APPLICATION TO THE RESIDENTIAL DESIGN
AND COMPATIBILITY COMMISSION (RDCC)

GENERAL MODIFICATION WAIVER

STREET ADDRESS: 1803 Clifford Ave., Austin TX 78702

Master Comment Report

BP.1 SITE PLAN & CALCULATIONS

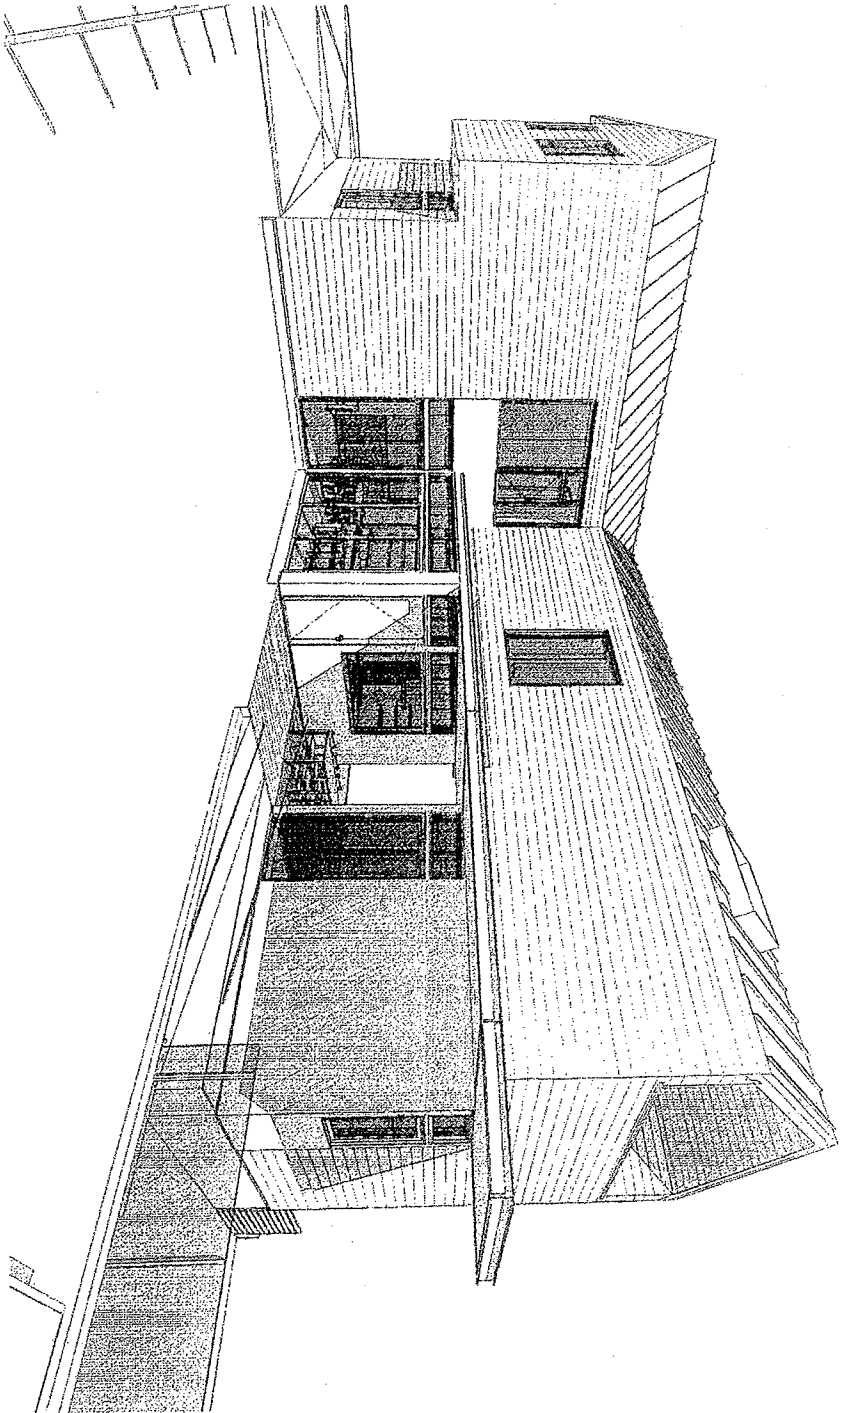
2. On the plans (sheet BP.1) remove the note regarding a porch encroachment per 25-2-1602. You are allowed to encroach up to 5 feet for a ground floor porch into the required front yard per 25-2-513 not 25-2-1602. In addition, the Rosewood NP did not adopt 25-2-1602 – so this design tool per 25-2-1602 is not available for this property. Revise accordingly.

4. On the full-size plan set – the scale is drawn accurately to stated scale on the Plot Plan – revise and correct this with your next Update.
5. Your front porch and the covered wood deck are all connected and count as one ground floor porch per review and it has second floor area above it. Thus, it must be accounted for in the FAR calculation. Note: Only 200sf of it may be exempted. As it appears this will push you over the maximum 2300sf allowed for this property. Substantial revisions will be required.
